SUBJECT: NuScale Power, LLC Response to NRC Request for Additional Information No. 304 (eRAI No. 9189) on the NuScale Design Certification Application

NuScale Response to NRC Request for Additional Information eRAI No. 9189

eRAI No.: 9189

Figure 5.1-2: Reactor Coolant System Simplified Diagram

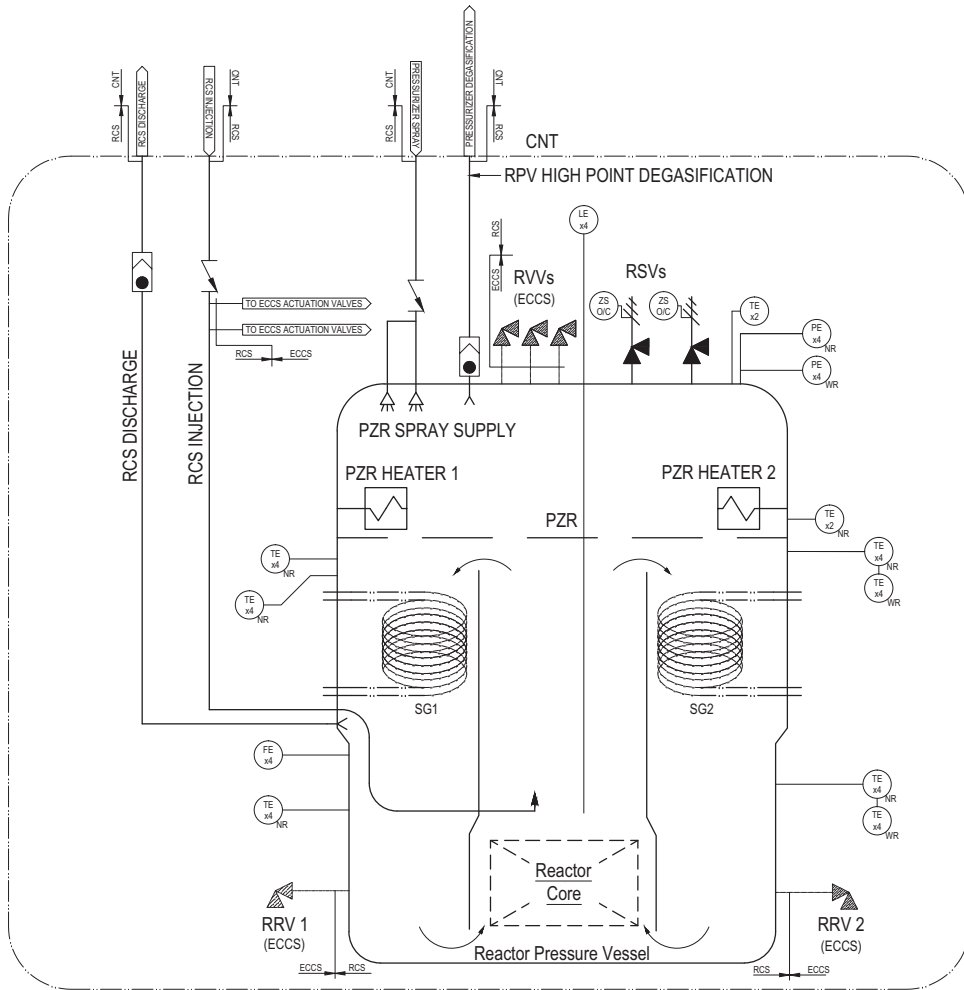
Part 1.) In FSAR Tier 2, Figure 5.1-2, the applicant shows a single branch off of the CVCS RCS Injection line that goes to the ECCS Actuator Valves. In FSAR Tier 2, Figure 6.3-1, the applicant shows two branches from the RCS that go to the ECCS valves. The staff cannot determine how a single branch, from one drawing connects to two branches on a different drawing, and thus cannot ascertain whether or not the system has been designed to minimize abnormal leakage. The staff requests the applicant to update the FSAR with the appropriate connection between Figure 5.1-2 and Figure 6.3-1 so that the staff can logically verify the line's adequacy.

There are two branches from the chemical volume control system (CVCS) reactor coolant system (RCS) injection line to the emergency core cooling system (ECCS). FSAR Tier 2, Figure 5.1-2 has been updated to show both branches.

FSAR Figures 5.1-2 and 6.3-1 have been revised as described in the response above and as shown in the markup provided in this response.
